22 June 2012

**RENOVATIONS & ADDITIONS  
NORTHWEST HIGH SCHOOL  
CLARKSVILLE, TN**

**ADDENDUM NO. TWO**

**INTERIOR PRECAST  
WALL FOOTING**

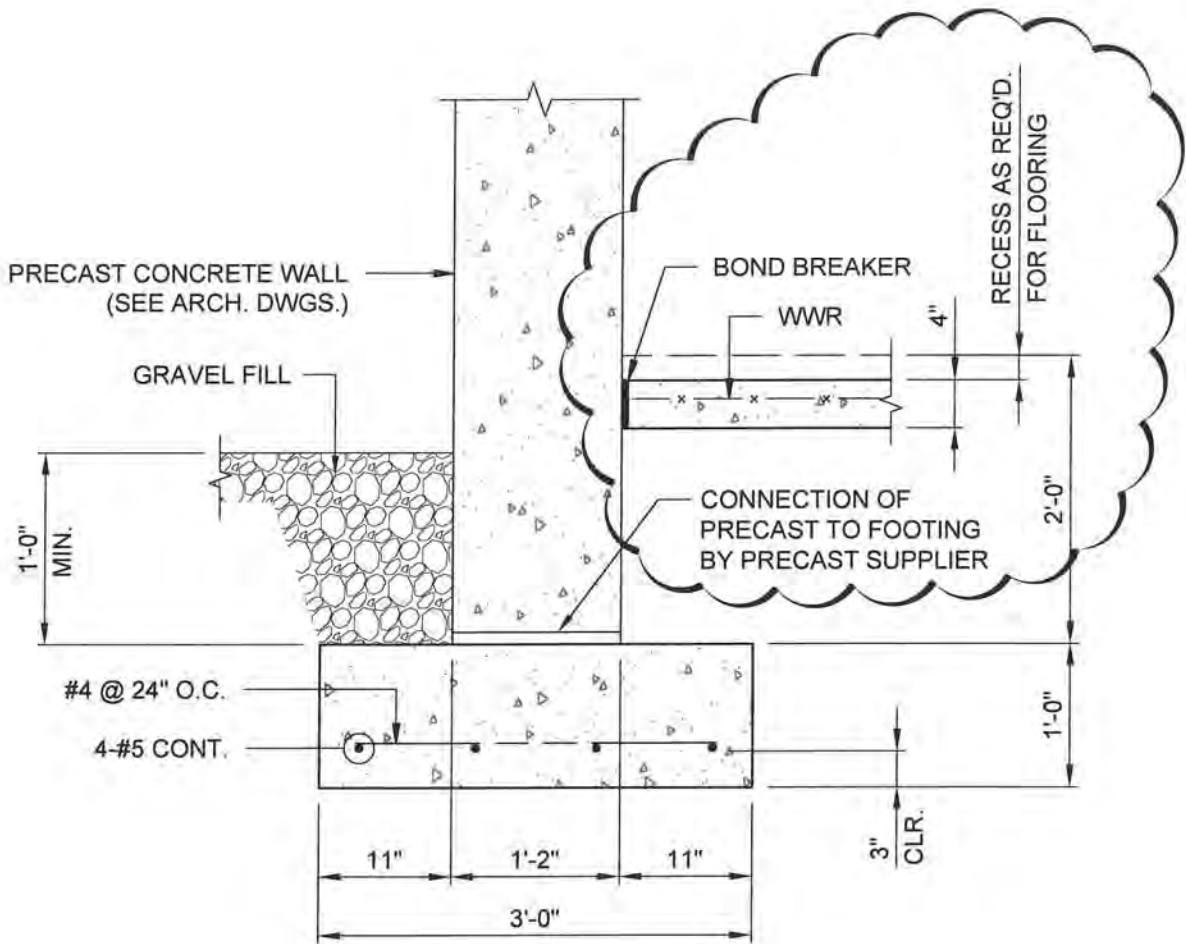
SHEET S202 – FOUNDATION DETAILS; Delete Details 3 and 7. Substitute therefor Drawings S202a and S202b attached hereto.

SG 2000  
 SNEEZE SHIELD

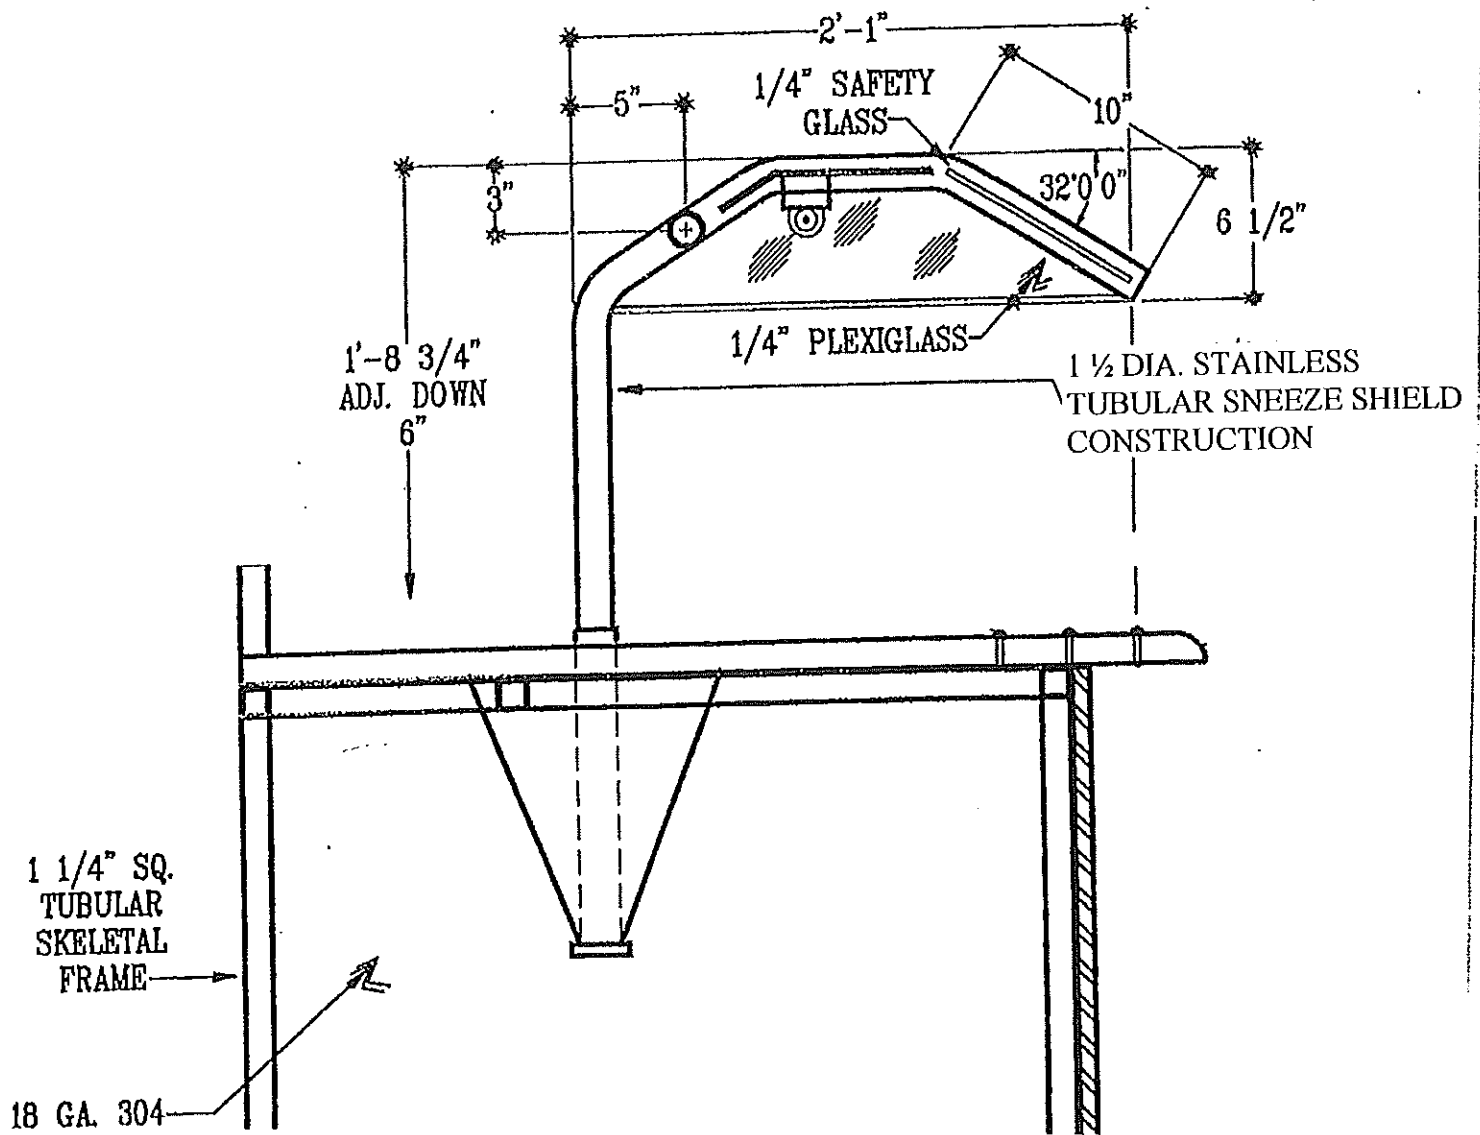
SHEET FS02 – EQUIPMENT PLAN; Add the drawing “SG2000 – SNEEZE SHIELD” dated 22 June 2012, attached hereto.

ADDENDUM #2  
**P118**  
 ATTACHMENT #1

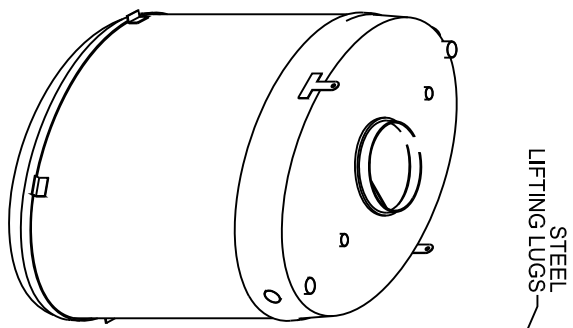
4. Refer to Sheet P118: See P118 Addendum #2 – Attachment #1 for added Note #9 and size of gas piping to generator.
5. Refer to Sheet P210 – Refer to A110 Note 16. This note applies to all trades and is the only location to pass through between 080 – Corridor and 081 – Serving.

- ① SEE DRAWING P120 FOR CONTINUATION.
- ② MAKE 1-1/2" CONNECTION TO 5" (4,790 CFH).
- ③ MAKE 1-1/2" CONNECTION TO 6" (5,040 CFH).
- ④ REPLACE EXIST. 2" GAS LINE WITH 6" GAS LINE.
- ⑤ MAKE 2" CONNECTION TO 6" (5,540 CFH).
- ⑥ REPLACE EXIST. 2-1/2" GAS LINE WITH 6" GAS LINE (5,540 CFH).
- ⑦ MAKE 1-1/2" CONNECTION TO 6" (5,790 CFH).
- ⑧ REPLACE 3" GAS LINE WITH 6" GAS LINE DOWN TO EXIST. GAS METER.
- ⑨ 2" GAS LINE TO GENERATOR (380 CFH).
- ⑩ CONNECT 2" GAS LINE TO 6" GAS ABOVE GRADE.
- ⑪ SEE "PLUMBING NOTE" #16 ON DRAWING P100.

# P310

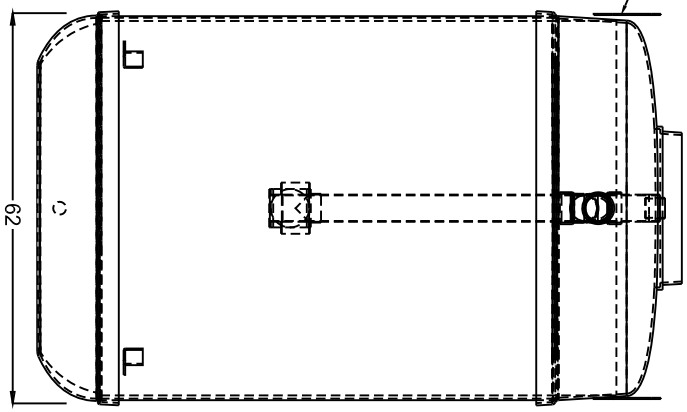
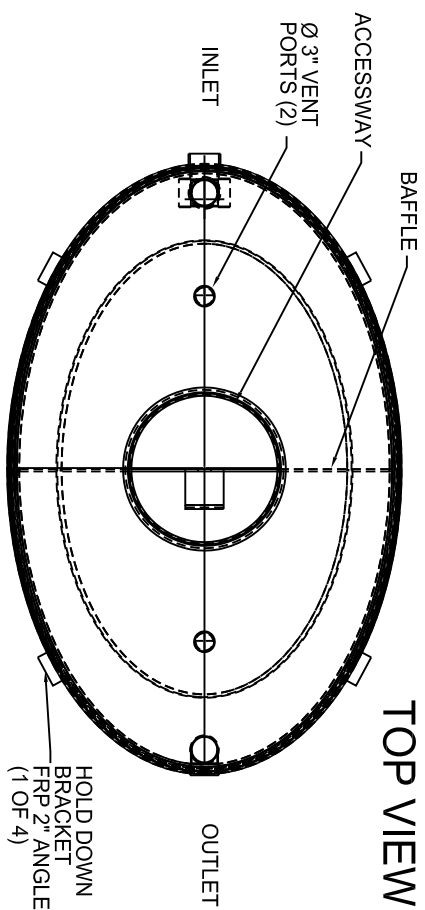
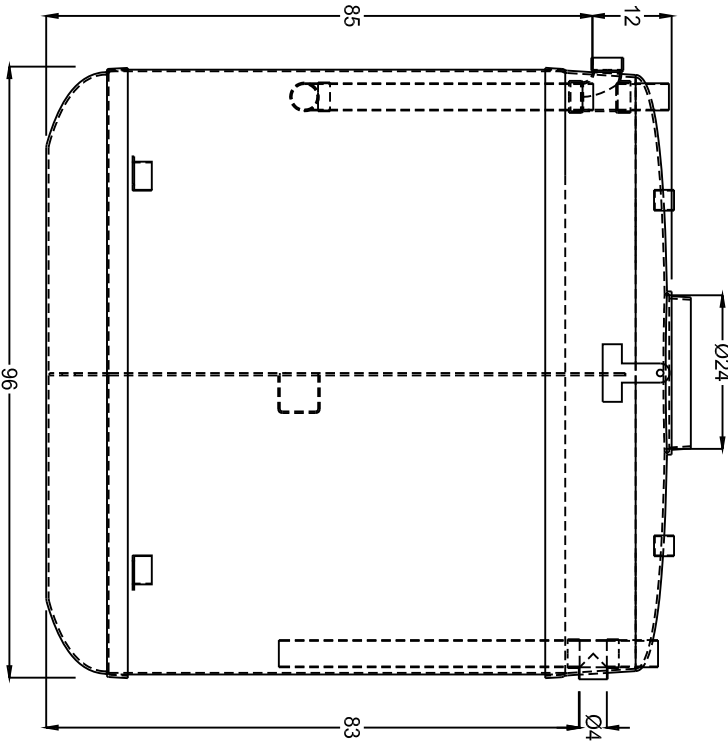
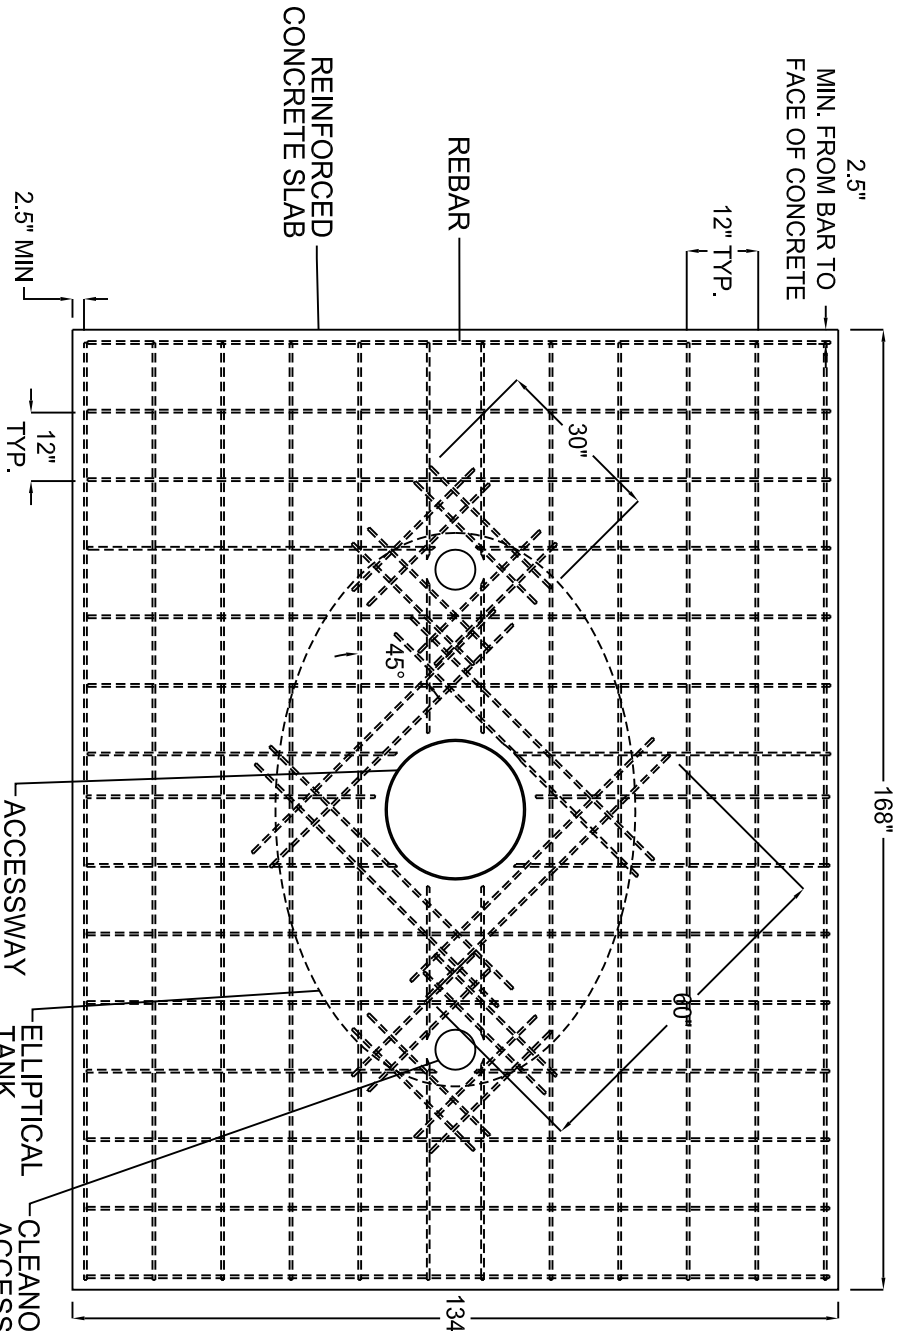
6. Refer to Sheet P308: Note #12 should be 2 inch Gas Line.
7. Refer to Sheet P310 – Typical 1500 Gallon Grease Separator detail does not contain dimensions. Refer to P310 Addendum #2 – Attachment #1 for correct detail.

ADDENDUM #2  
**P310**  
 ATTACHMENT #2

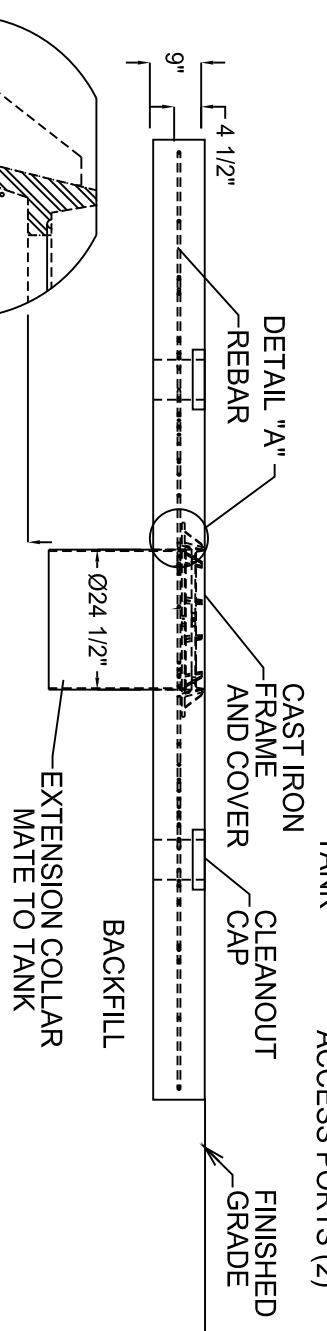
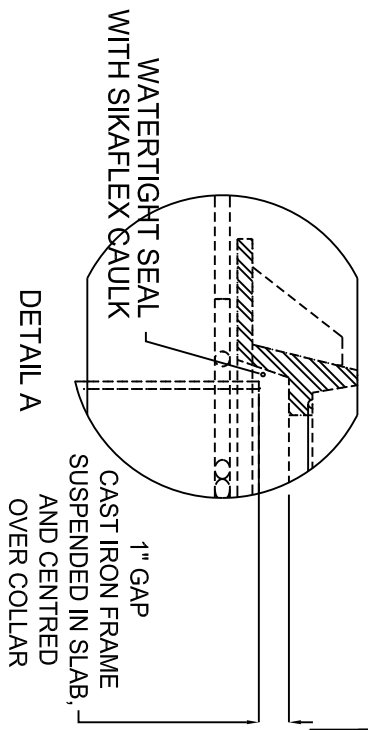
8. Refer to Sheet P310 – H2O Traffic Loading Slab for Single Elliptical Tank detail does not contain dimensions. Refer to P310 Addendum #2 – Attachment #2 for correct detail.

- NOTES:
- CONCRETE TO BE 28 DAY COMPRESSIVE STRENGTH TO 4000 PSI.
  - NO. 4 REBAR ( $\varnothing$  1/2") GRADE 60 STEEL PER ASTM A615; CONNECTED WITH TIE WIRE REBAR SPACING, 4" AROUND ACCESS OPENINGS.
  - ALL PENETRATIONS TO BE SLEEVED OR HAVE SLIP CONNECTIONS.
  - MINIMUM 36" FROM TOP OF SLAB TO TOP OF TANK.
  - EXTEND COMPACTED BACKFILL A MINIMUM 3 FT. BEYOND ALL SIDES OF TANK.

# CITY MULTI SYSTEM SCHEMATIC DWG.

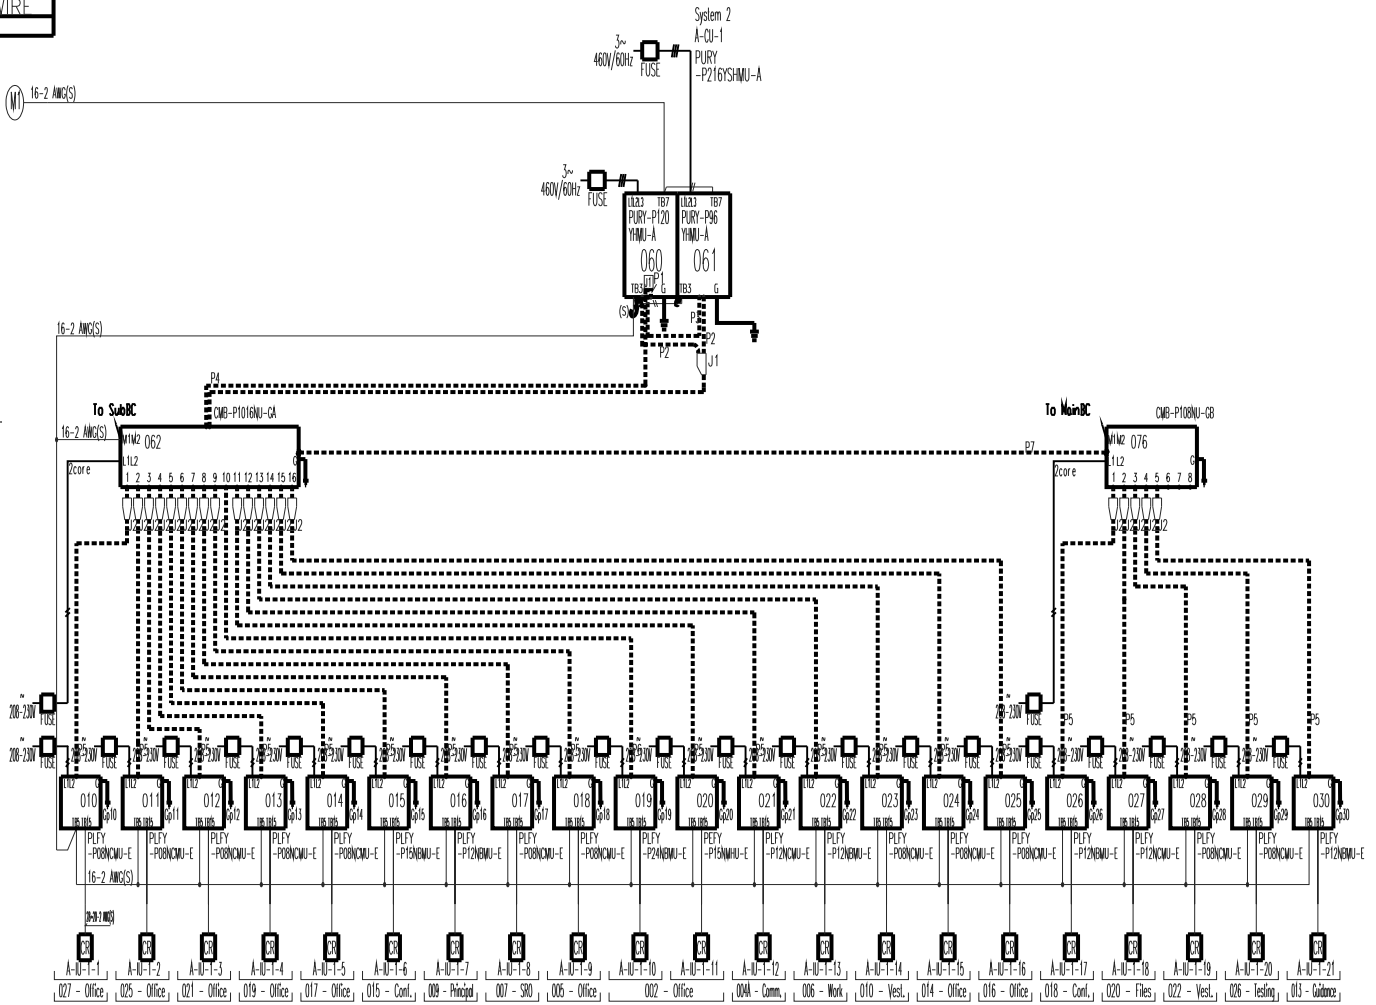
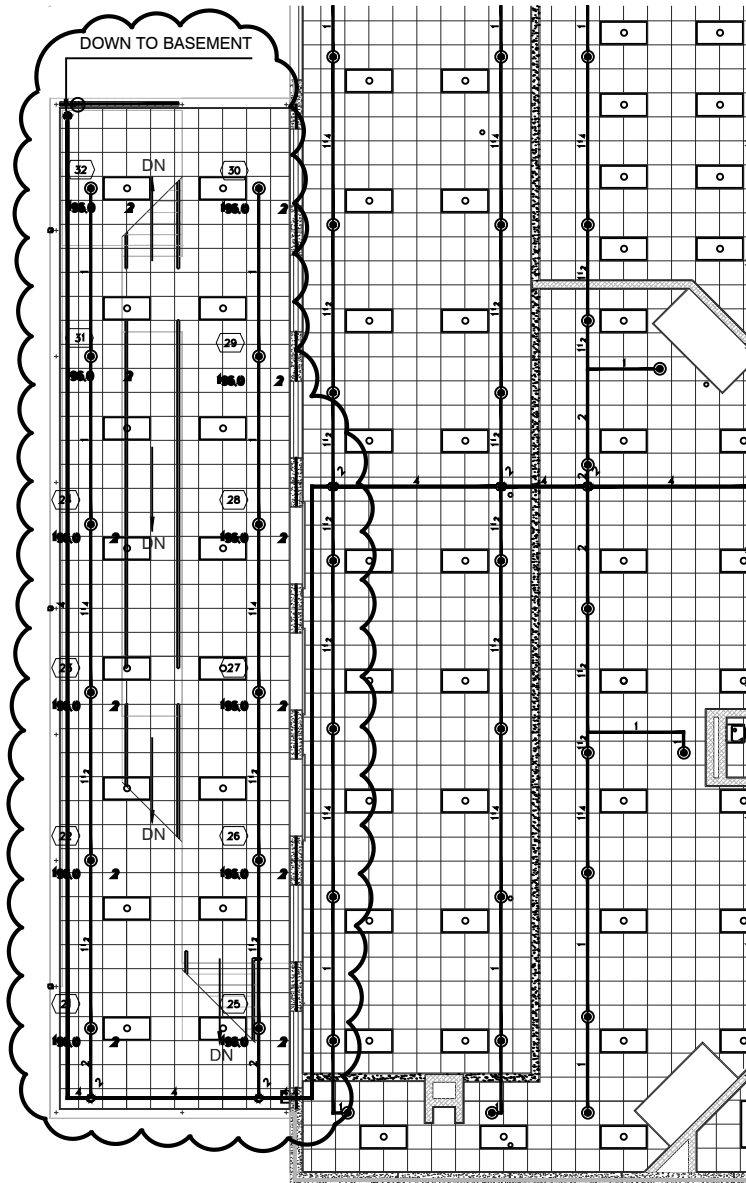
15. Refer to Sheet M202 – Add schedule for A-IU-1-21 shown on M-102. Refer to M202 Addendum #2 – Attachment #1.
16. Refer to Sheet M202 – Revise Piping Schematic to include A-IU-1-21. Refer to M202 Addendum #2 – Attachment #2.
